PHASE I INSPECTION REPORT
NATIONAL DAM SAFETY PROGRAM
DANSVILLE RESERVOIR DAM
N.Y. 431
DEC I.D. NO. 42-999
GENESEE RIVER BASIN
STEUBEN COUNTY, NEW YORK

Name of Dam: Dansville Reservoir Dam
N.Y. 431

DANSVILLE RESERVOIR DAM
N.Y. 431
DEC I.D. 42-999
JUNE 26, 1981

PLATE 4
 DANSVILLE RESERVOIR DAM
 GENERAL PLAN
 FIELD INSPECTION NOTES
 FIELD INSPECTION DATE : JUNE 26, 1981

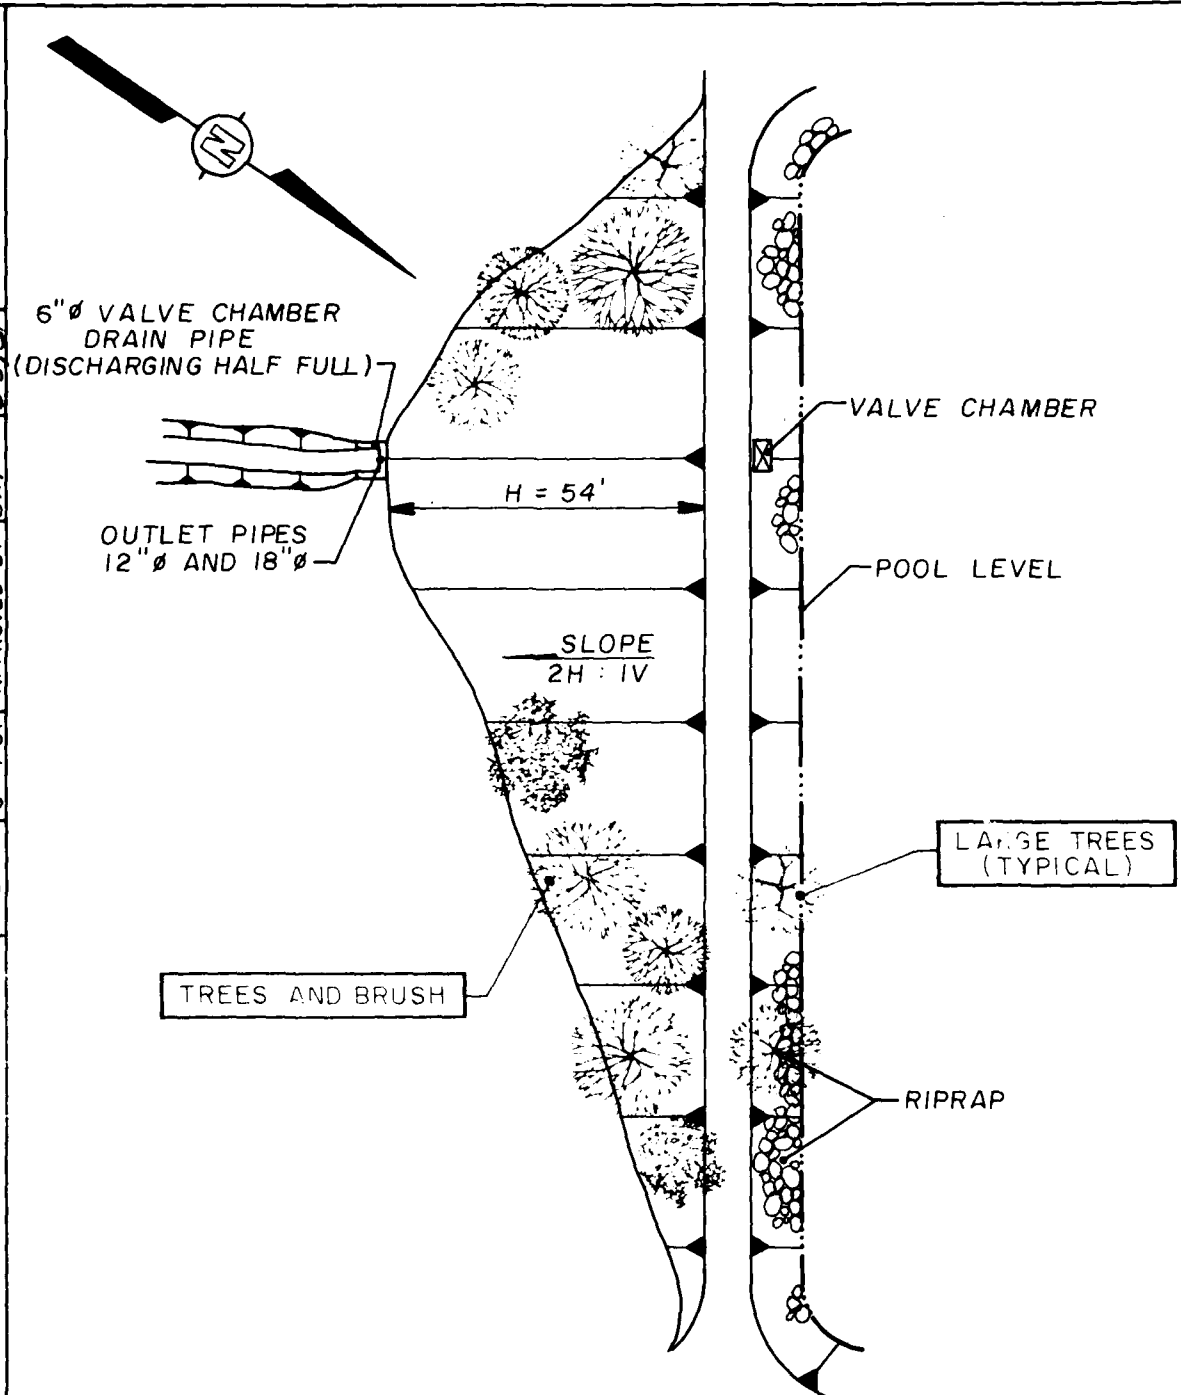
No signs of distress, misalignment, or seepage were observed. The faces and crest of the dam are covered with large trees and brush. Most of the larger trees are located on the upstream slope. Growth on the dam is not considered to be extensive enough to significantly hamper inspection. The top of the dam was surveyed relative to the spillway crest level and found to be in the range of 0.1 foot below to 0.4 foot above the design elevation.
